Re: Sunrise Project Modification 7 – Request for Information (EPA Advice on Submissions Report)

Response to Air Quality-related Matters in the EPA Advice on the Submissions Report

Sunrise Project - Project Execution Plan Modification - Response to Noise-related Matters in the EPA Advice on the Submissions Report

ATTACHMENT 1 Modelled ground-level concentrations

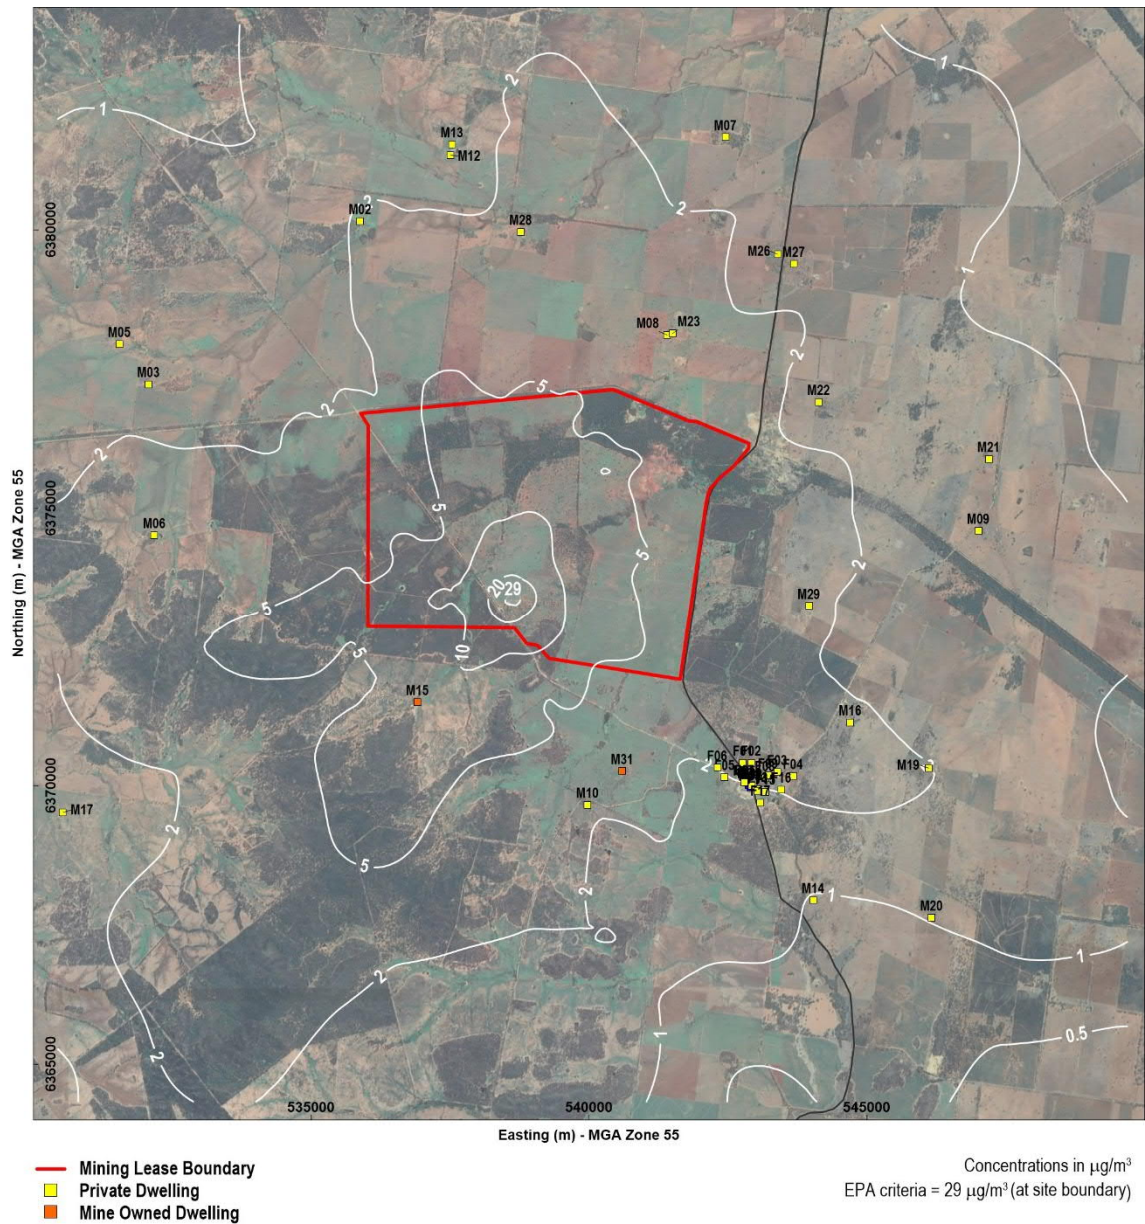
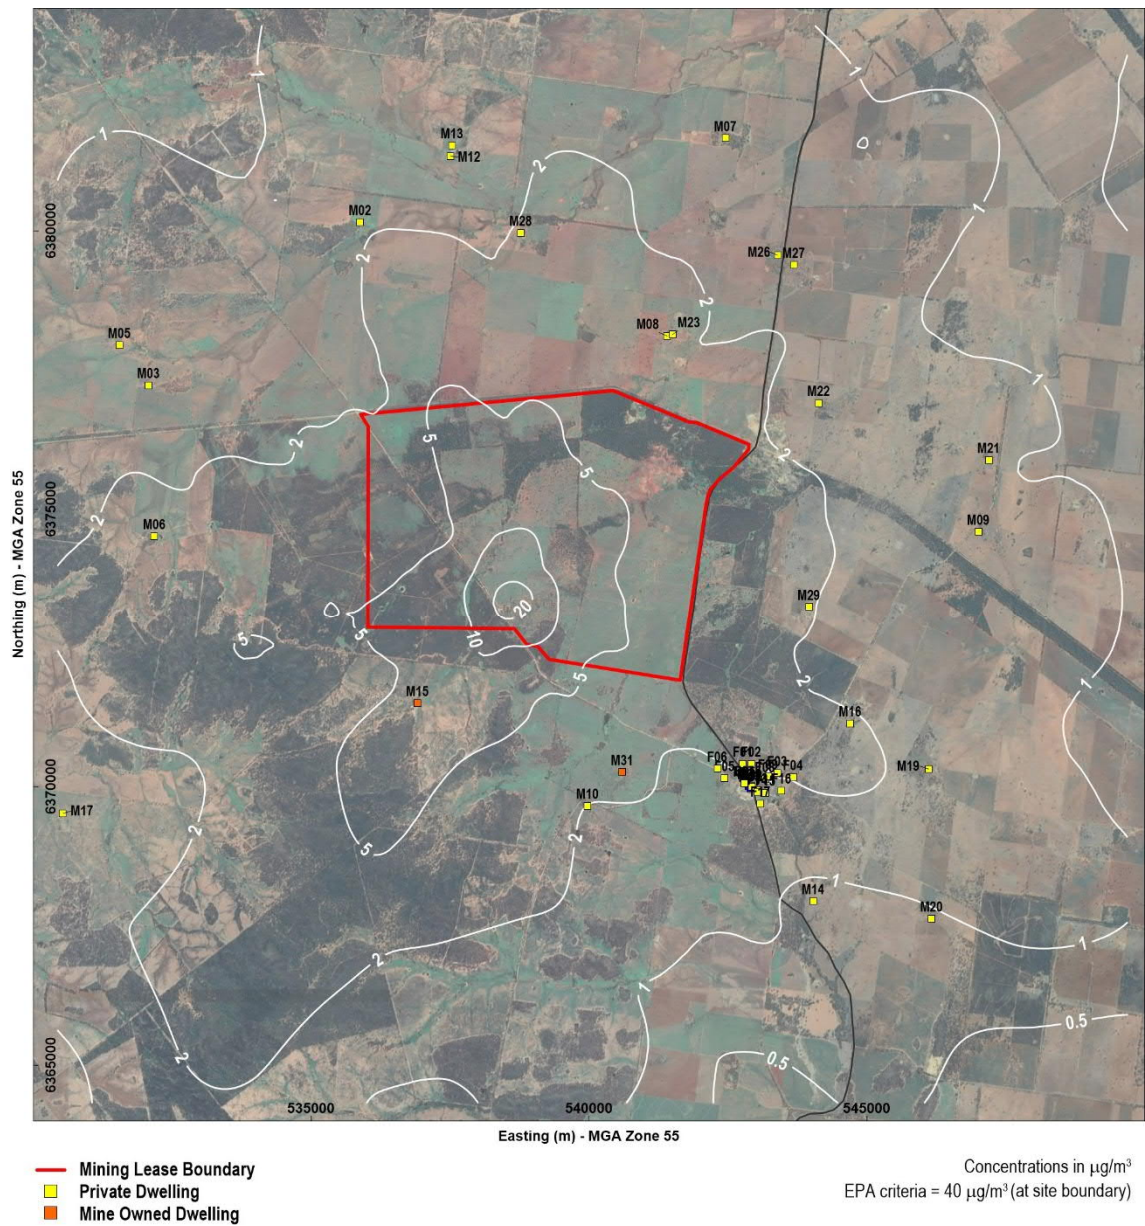
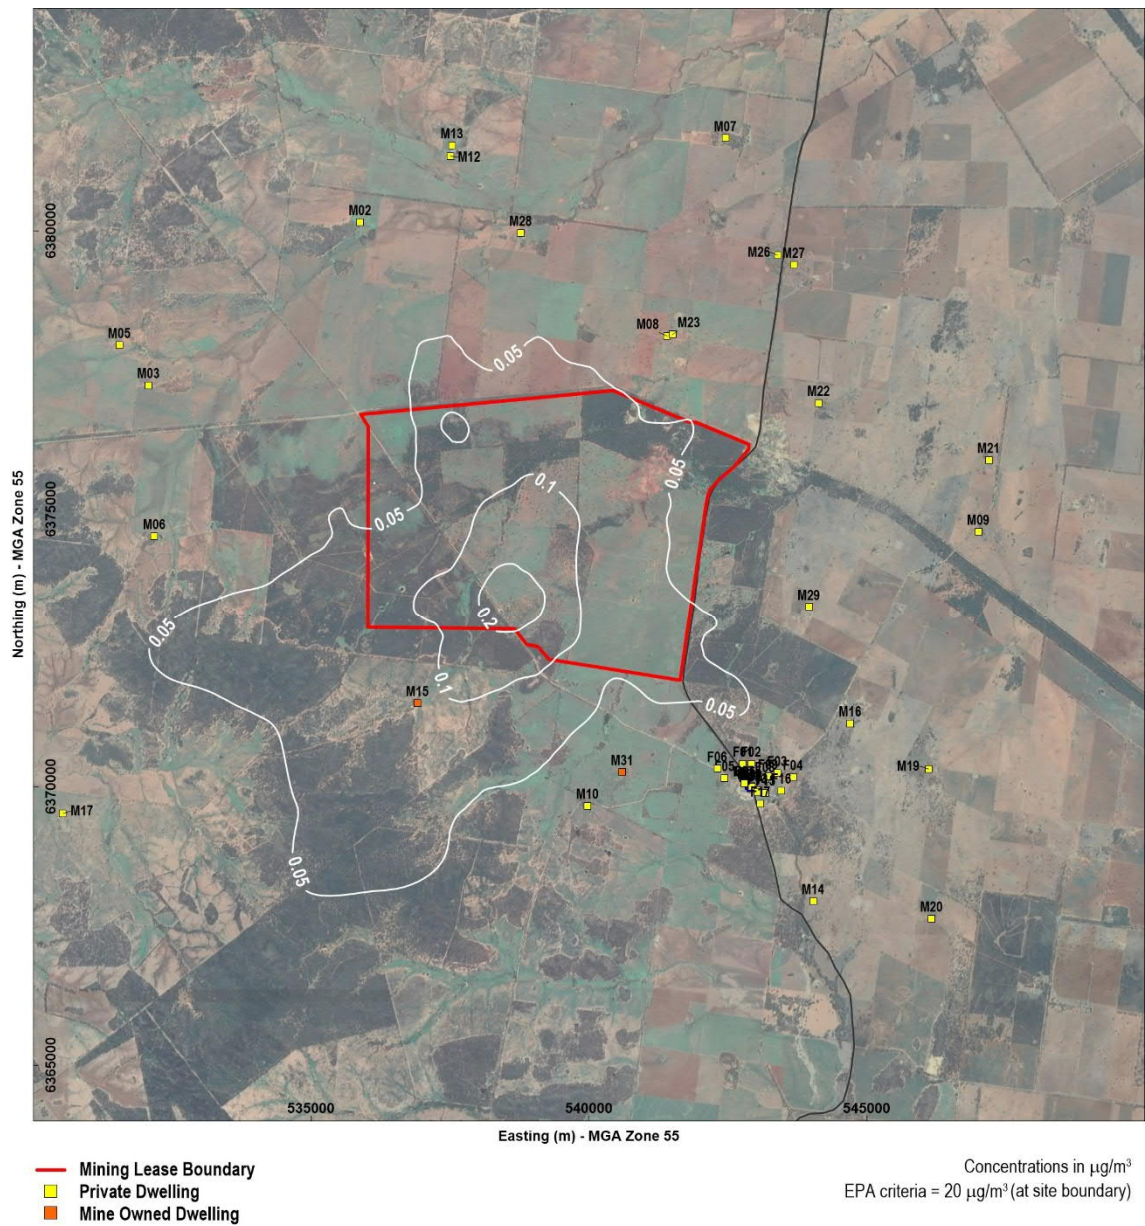
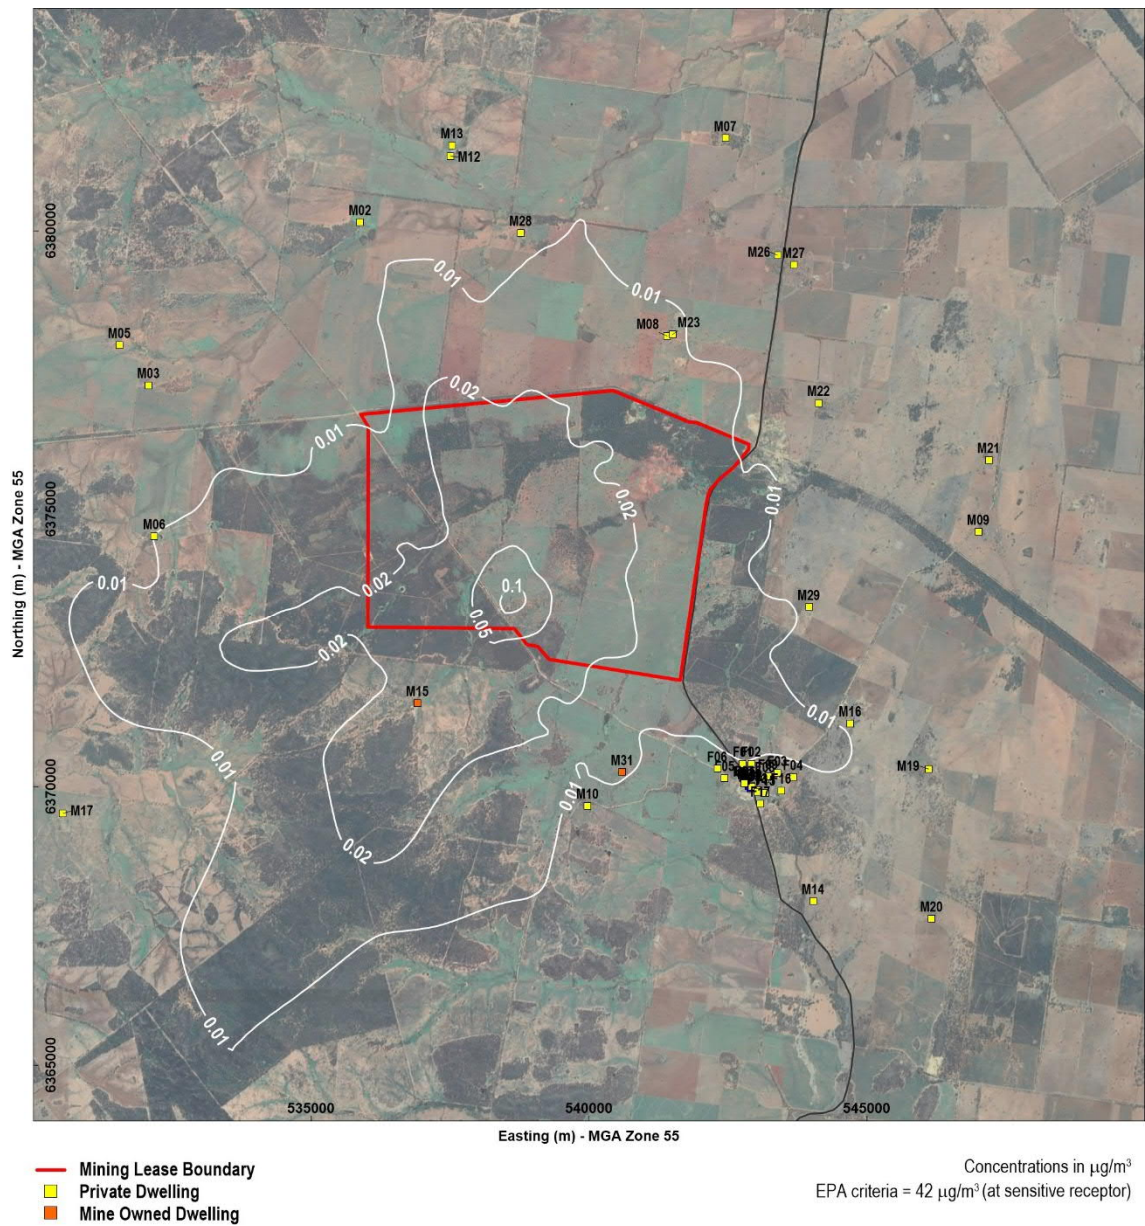
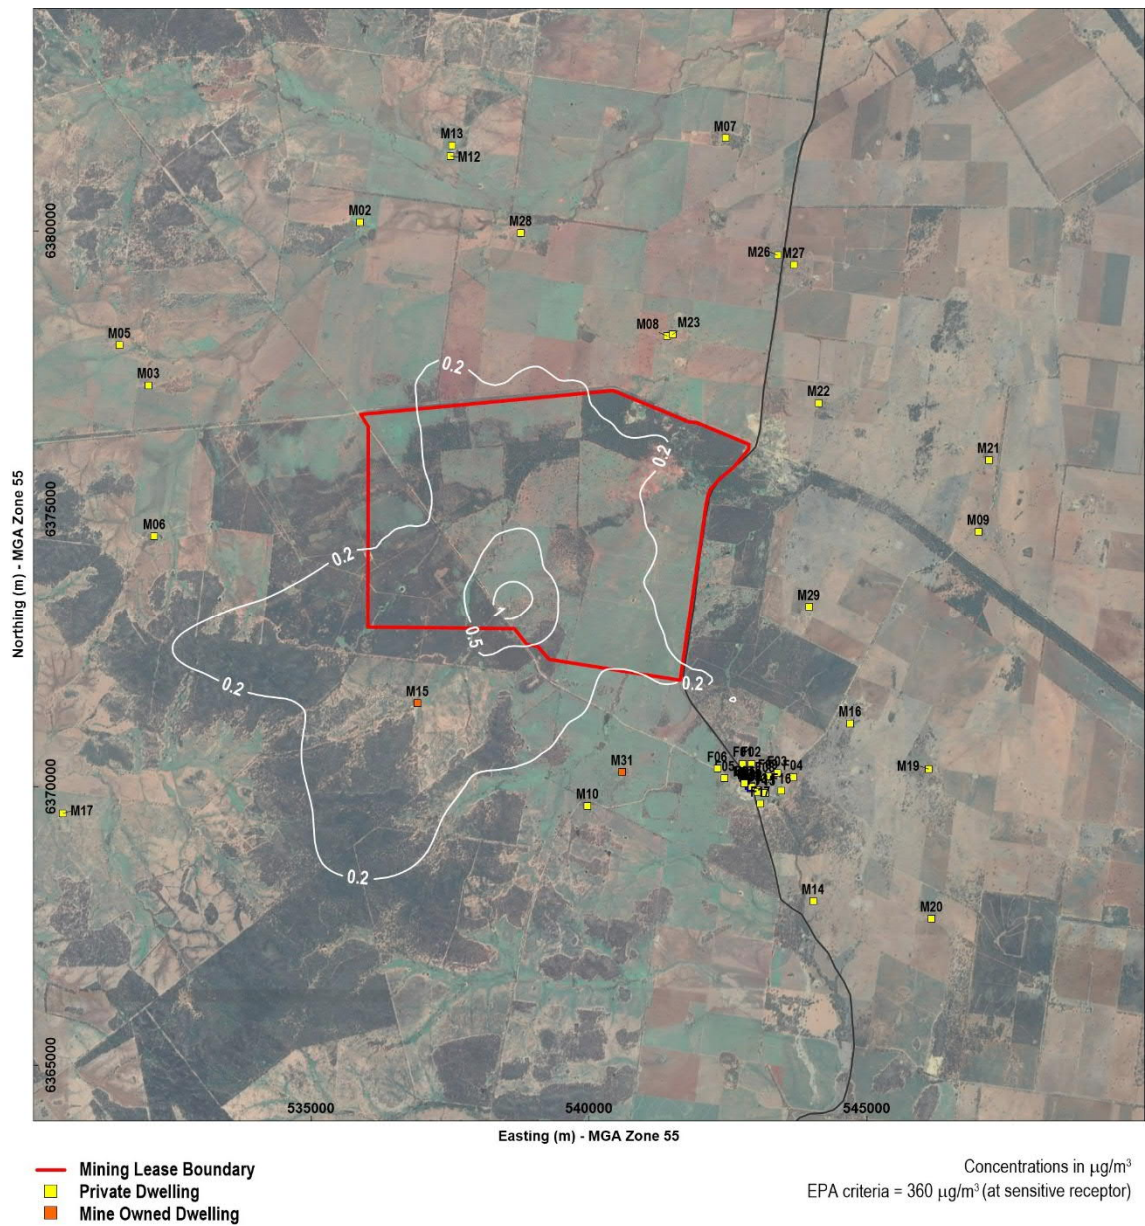
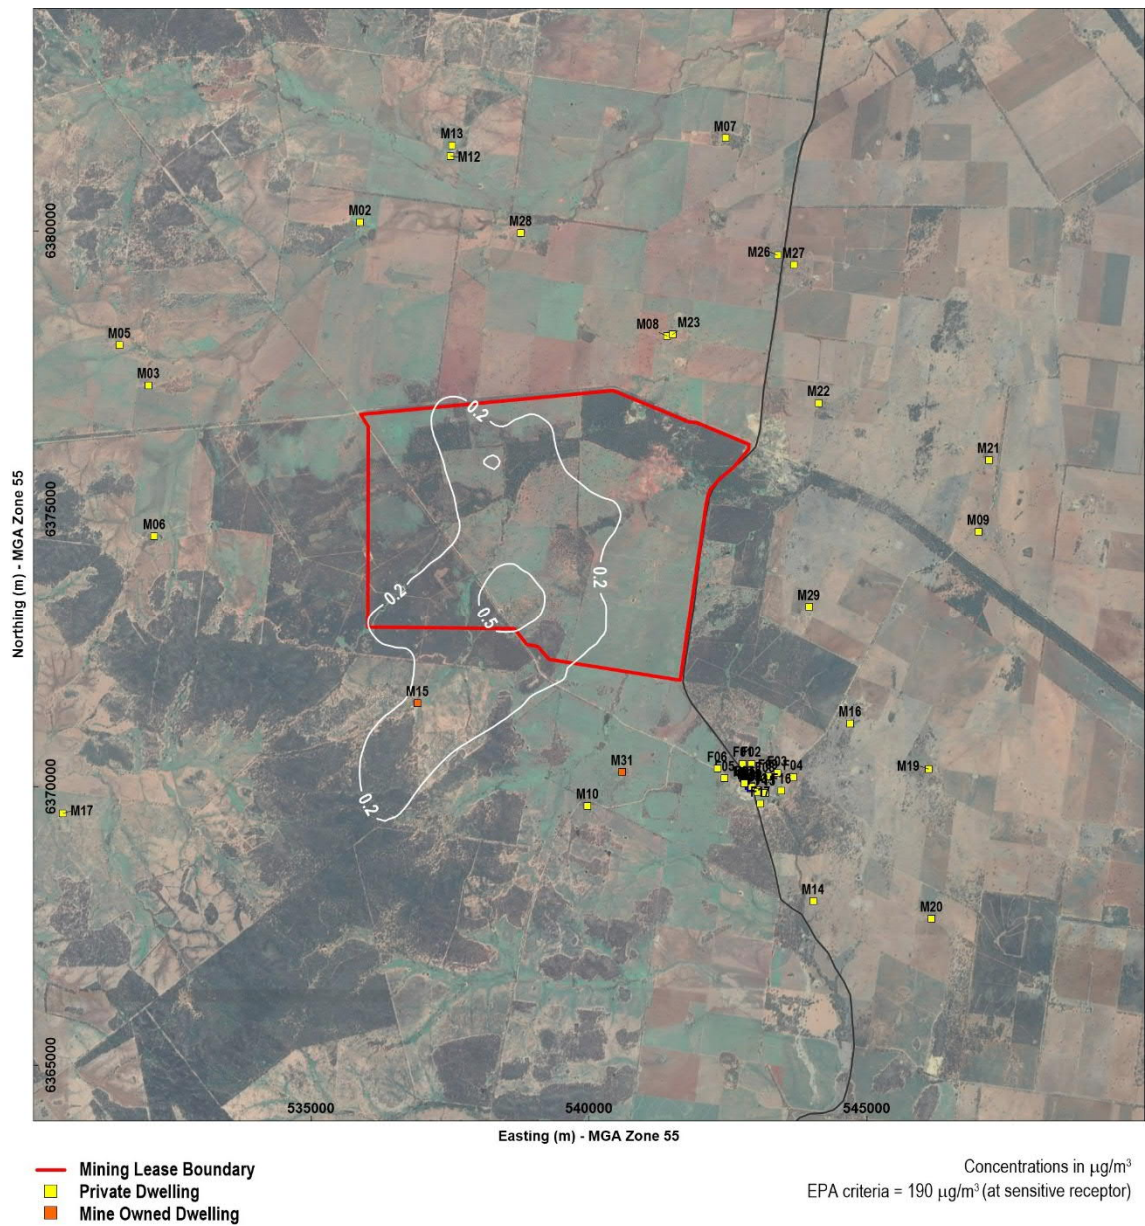
- 2) Demonstrate that the speciated VOCs assessed have the greatest potential for ground level impacts. The EPA recommends additional analysis comparing the magnitude of speciated VOCs with relevant impact assessment criteria to demonstrate the speciated VOCs assessed are representative of worst-case emissions and potential impacts.
- 3) Revise the Air Quality Impact Assessment to ensure that emissions and potential impacts are based on reasonable worst-case emissions. This includes:
 - i. an assessment of the potential impacts of additional VOCs identified through the additional analysis described above.
 - ii. consideration of plant specific emission performances.

Based on the modelled ground-level concentrations from Attachment 1, the following conclusions can be made:

- Benzene concentrations do not exceed the air quality assessment criterion (29 µg/m³) beyond the mine and processing facility boundary for 99.9% of the time (i.e. 99.9th percentile).

- 1-3 butadiene concentrations do not exceed the air quality assessment criterion (40 µg/m³) beyond the mine and processing facility boundary for 99.9% of the time (i.e. 99.9th percentile).

- Formaldehyde concentrations do not exceed the air quality assessment criterion (20 µg/m³) beyond the mine and processing facility boundary for 99.9% of the time (i.e. 99.9th percentile).

- Acetaldehyde concentrations do not exceed the air quality assessment criterion (42 µg/m³) at the nearest sensitive receptors for 99.9% of the time (i.e. 99.9th percentile).

- Toluene concentrations do not exceed the air quality assessment criterion (360 µg/m³) at the nearest sensitive receptors for 99.9% of the time (i.e. 99.9th percentile).

- Xylenes concentrations do not exceed the air quality assessment criterion (190 µg/m³) at the nearest sensitive receptors for 99.9% of the time (i.e. 99.9th percentile).
